HISTORIC DISTRICT COMMISSION NOTICE OF DENIAL

Application Number: HDC2025-00446

PROJECT ADDRESS: 2491 Longfellow

HISTORIC DISTRICT: Boston-Edison

Fig 1, by Applicant: Proposed installation of the gravel pad and walkway, fence, and tree removal.

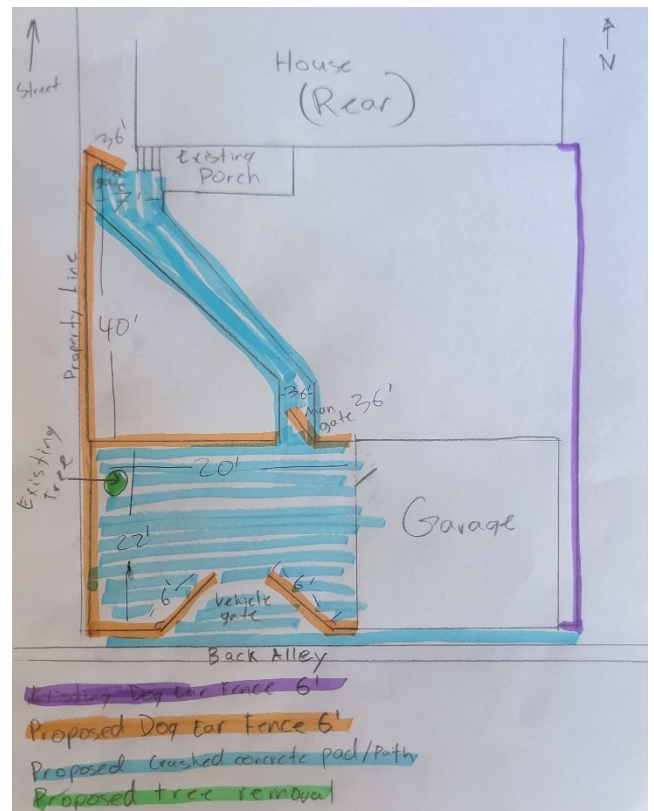
- Staff finds that the proposed gravel parking area and walking pathway are appropriate.
- Staff has the opinion that the proposed 6' wood panel fence along the rear property line and inside the backyard are appropriate as they provide continuity to existing fence conditions and follow the HDC guidelines. Staff received clarification from the applicant's contractor that the reason for waiting one year is allow the treated wood to age before being stained.

FRONT & REAR PORCHES & DOORS

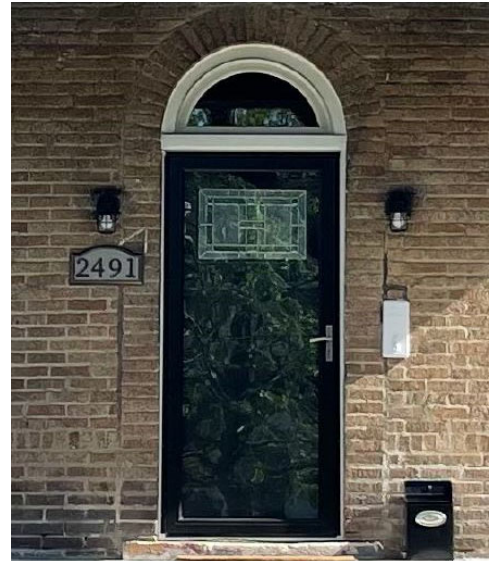
- It is staff's opinion that the pairing of the round-columns at the front porch are characteristic of the Colonial Revival architecture of the property and are character defining features of the house. Each pair, two at each end of the porch, and two side by side, totalling eight (8) columns have been reduced to four (4) single square columns, reducing the form, altering the shape and color, and modifying the design of the columns which greatly alters the porch's distinctive, historic expression. *(See photo 1, and designation image.)* However, it is staff's opinion that the repoured front porch deck, and the rebuilt front porch wingwalls and steps do meet the Standards and are appropriate.

- Staff observed that the original rear porch has been removed and new porch constructed. Scars left on the brick face above the new porch roof show the original extent of the rear porch, which was likely a flat roof that extended to, but stopped short of the window at the first floor in alignment with the windows above it. While the best approach is to closely align the new construction with the historic location of the former roof, it is staff's opinion that the newly constructed rear porch is not demonstrably inappropriate at this rear elevation because it consists of wood materials, has a wood decking, skirting and wood railing that meets the Standards and conforms to the district's Elements of Design.
